Subject: **PALO VERDE SOLAR I, LLC'S PETITION FOR AMENDMENT  
BLYTHE SOLAR POWER PROJECT  
DOCKET NO. (09-AFC-6C)**

# BLYTHE SOLAR POWER PROJECT

**AMENDMENT**  
**(09-AFC-6C)**

Designed By	
Drawn By	
Checked By	
Date	12/17/10

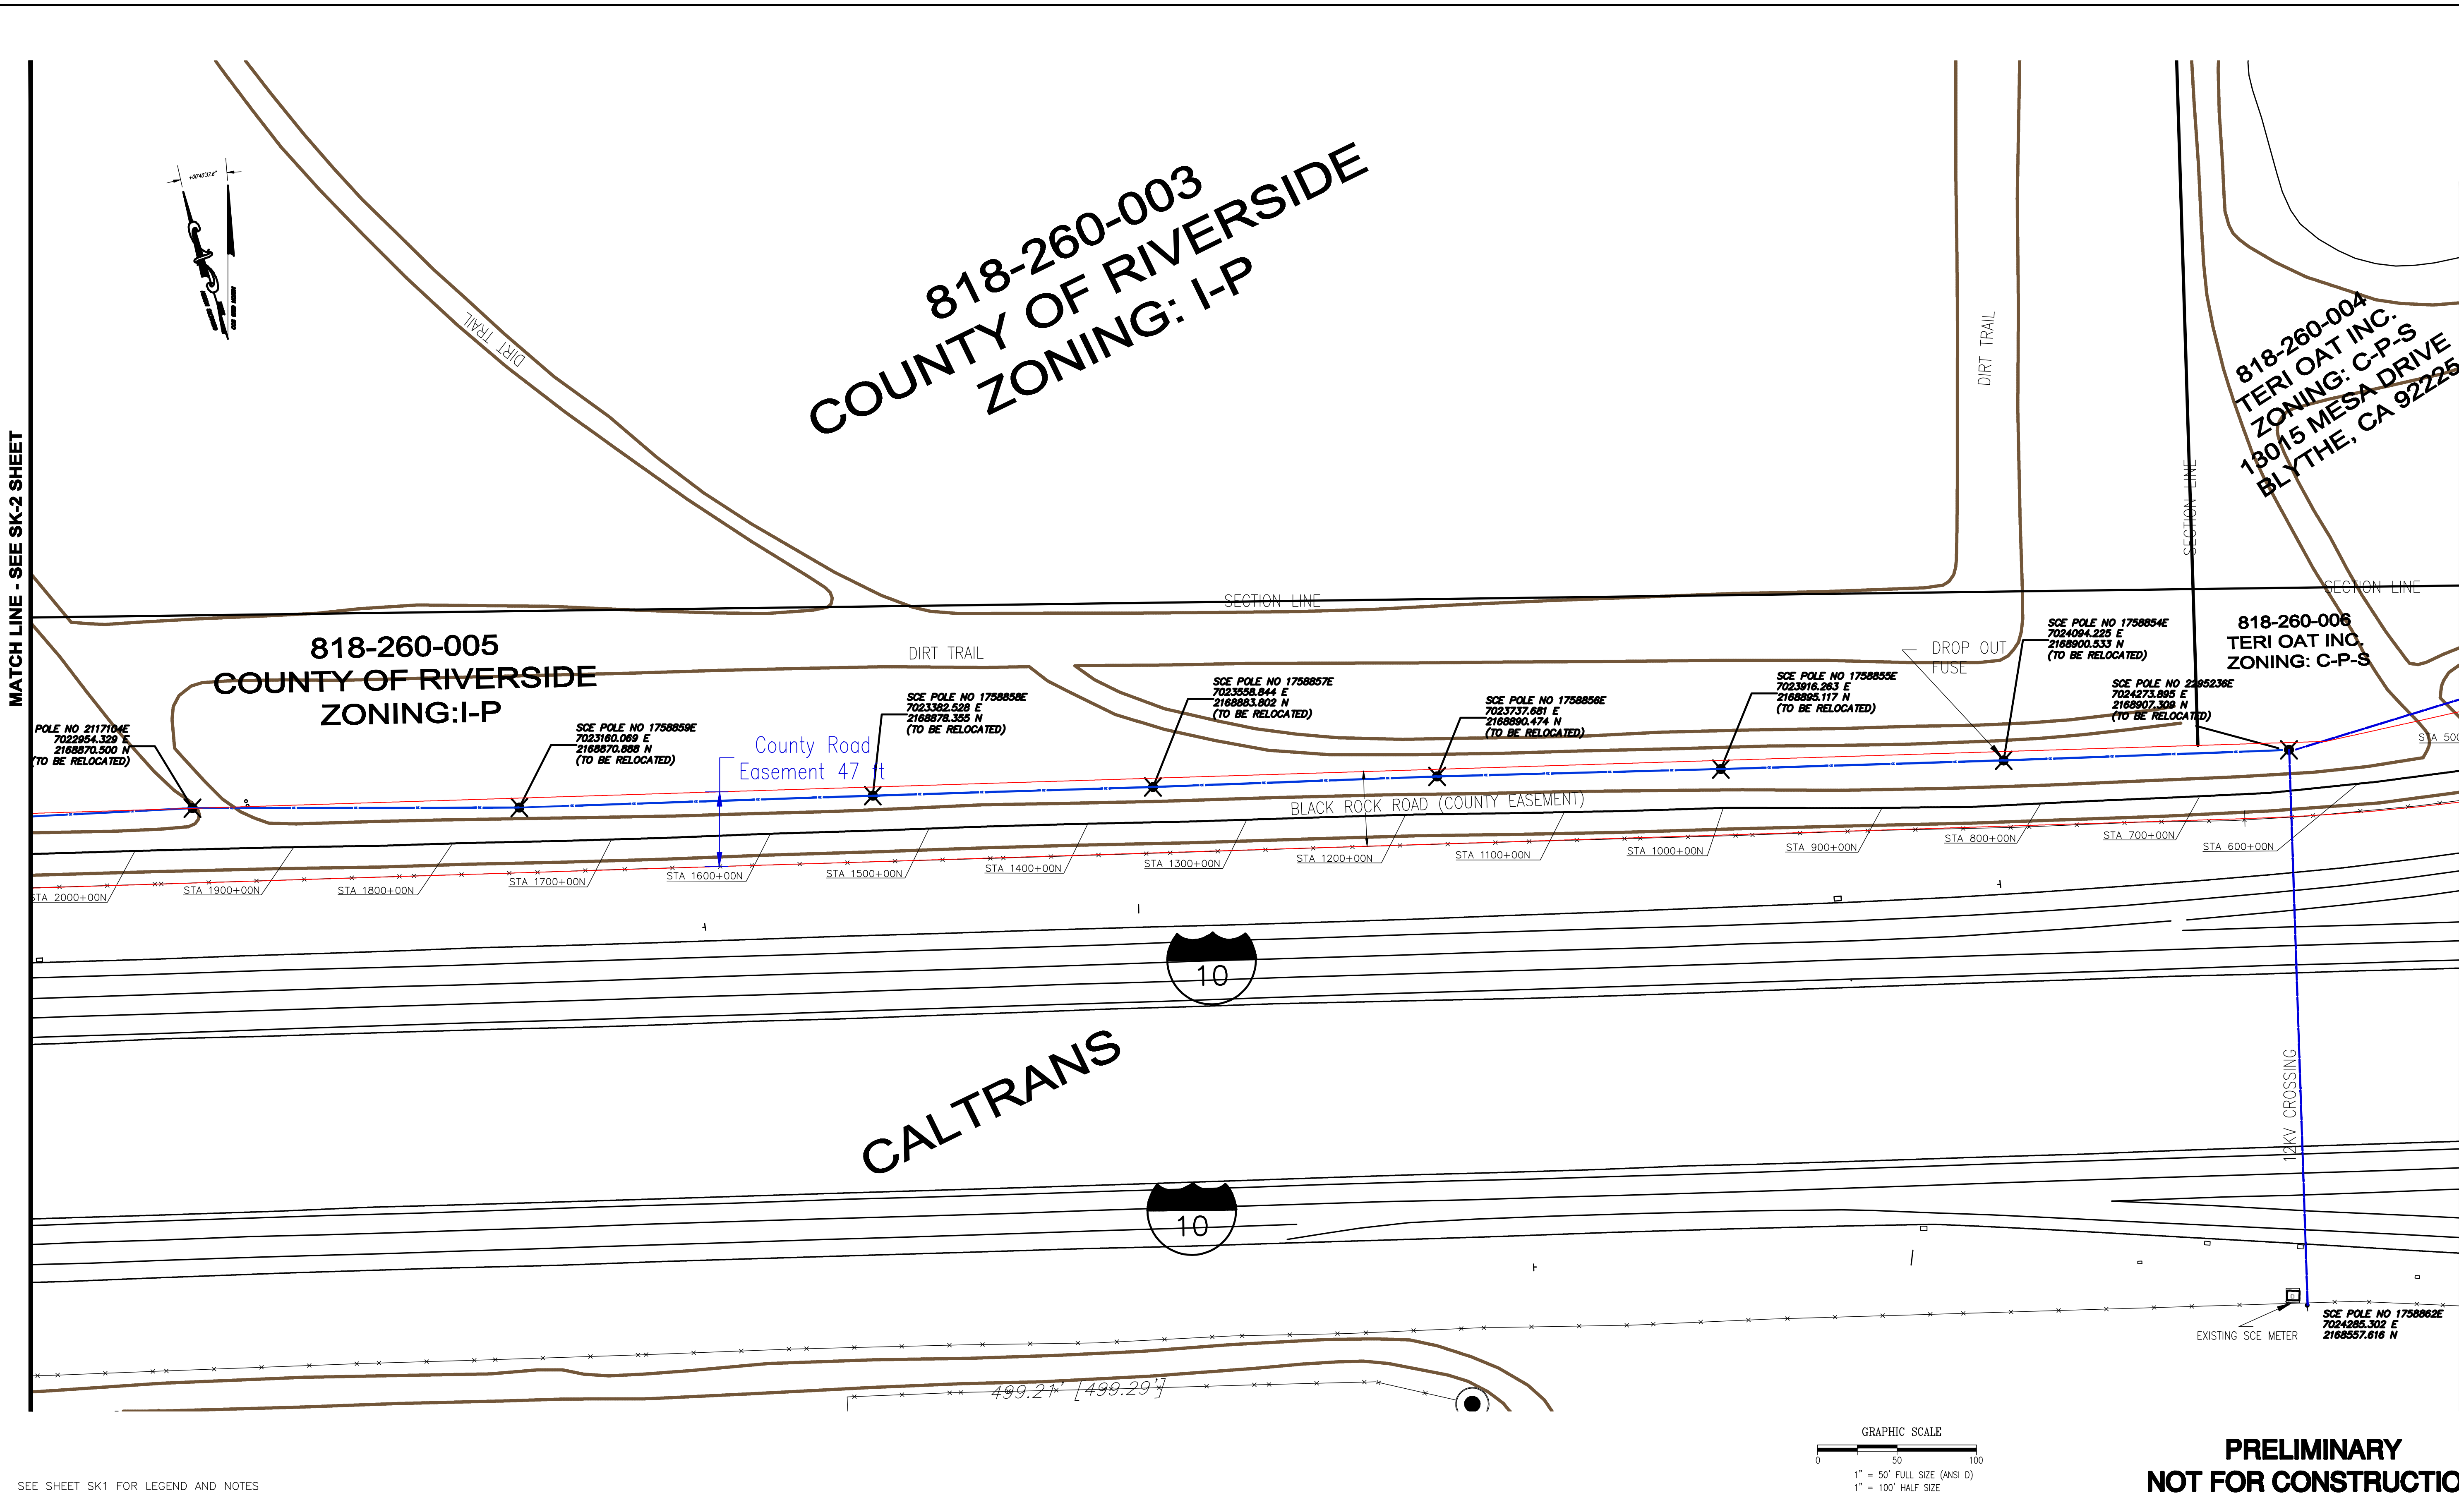
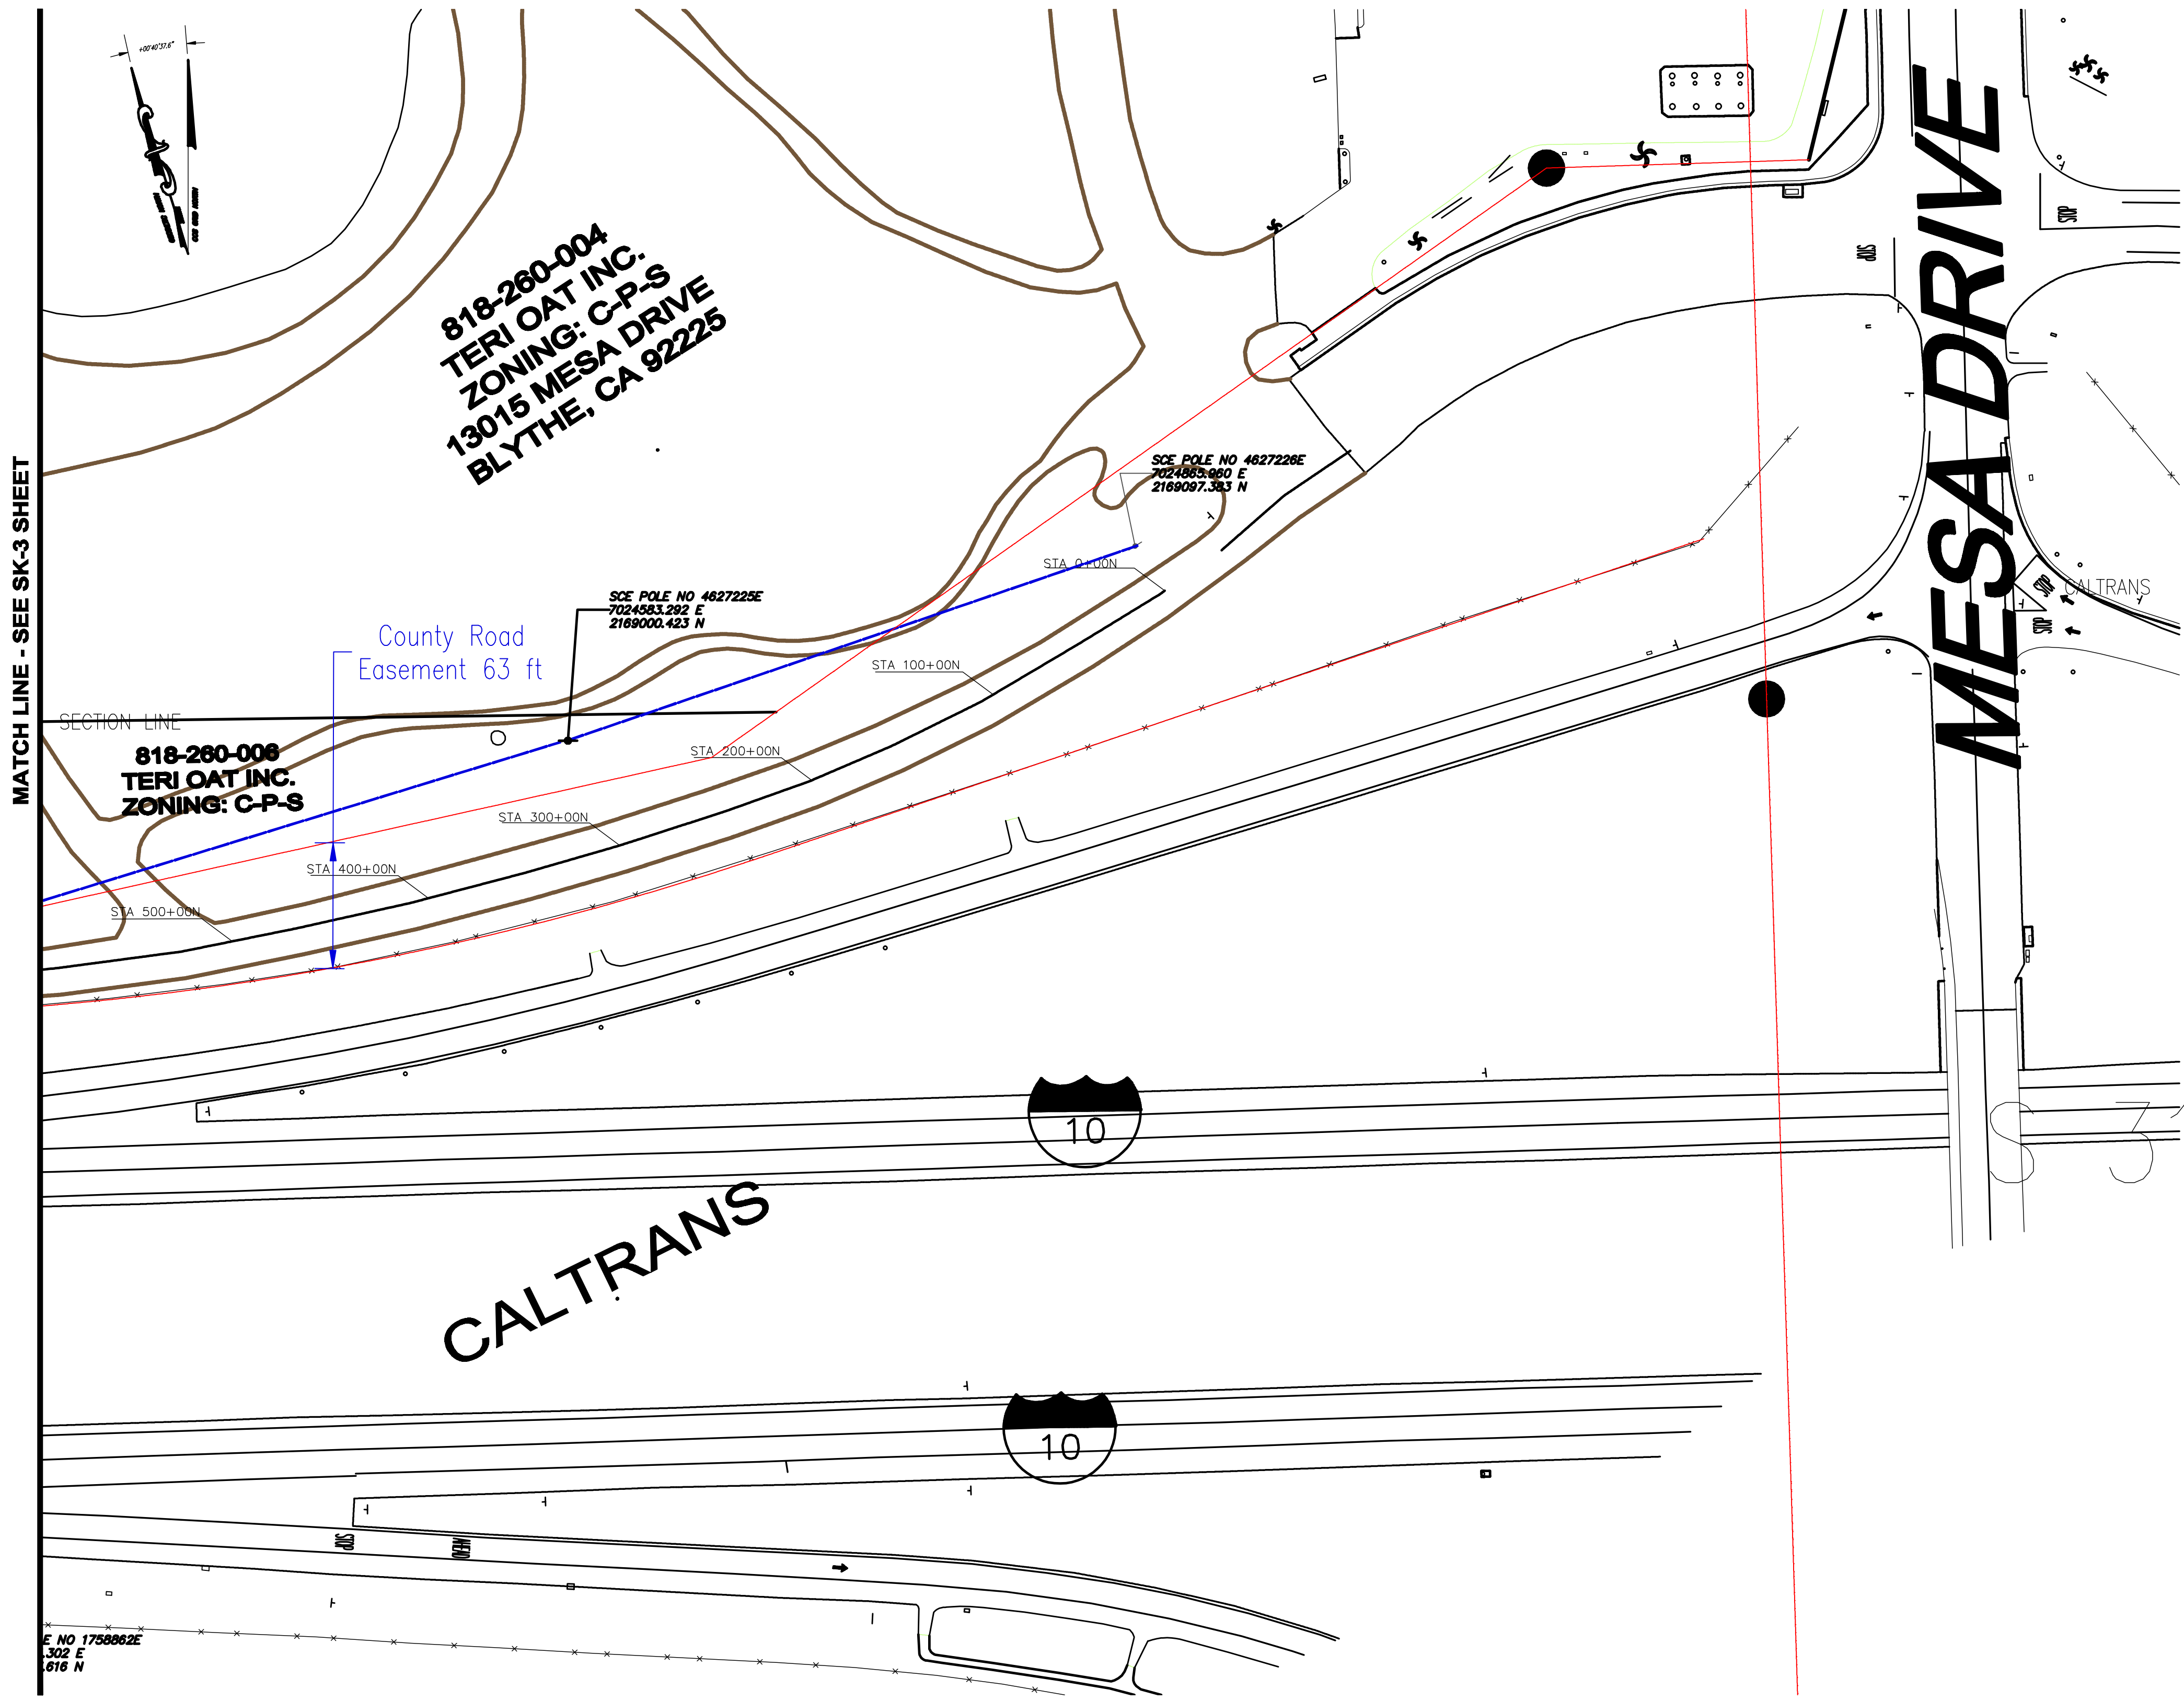
During final design of the access road it was discovered that expansion of a portion of Black Rock Road could not be accommodated without relocating some of the adjacent transmission poles supporting SCE's existing 12 kV Distribution Line that currently serves the CalTrans Weigh Station. Eighteen poles will be relocated approximately 10 to 15 feet. The work will be performed by SCE and will involve removing existing poles and either replacing them with new wood transmission poles or undergrounding. The new transmission poles may be 5 feet taller than existing and will be placed within an expansion of the existing County Right-Of-Way. **Figure 2-3** identifies the extent of the Black Rock Road transmission pole relocation.

- NOTES:**
- SOLAR MILLENNIUM TO IMPROVE BLACK ROCK ROAD WEST FROM MESA DRIVE TO MAIN PLANT ACCESS ROAD A DISTANCE OF APPROXIMATELY 1 MILE. REFER TO PRELIMINARY CIVIL DESIGN DRAWING 2008-045-CD-200 FOR TYPICAL SECTION
  - EXISTING 12KV DISTRIBUTION LINE BETWEEN POLE 2117111E AND 2295236E TO BE RELOCATED BY SOUTHERN CALIFORNIA EDISON TO CONFORM WITH MINIMUM RIVERSIDE COUNTY REQUIREMENTS AND ENABLE SOLAR MILLENNIUM CONSTRUCTION ACTIVITY
  - FINAL RELOCATED POLE LOCATIONS TO BE PROVIDED BY SCE IN ACCORDANCE WITH RIVERSIDE COUNTY STANDARDS AND SPECIFICATIONS FOR ROAD IMPROVEMENT WORKS INCLUDING ORDINANCE 461
  - COORDINATES TO NAD 83 STATE PLANE VI COORDINATE SYSTEM, U.S. SURVEY FOOT
  - SOLAR MILLENNIUM HAS COMPLETED ENVIRONMENTAL STUDIES ALONG LENGTH OF BLACK ROCK ROAD REQUIRING UPGRADE
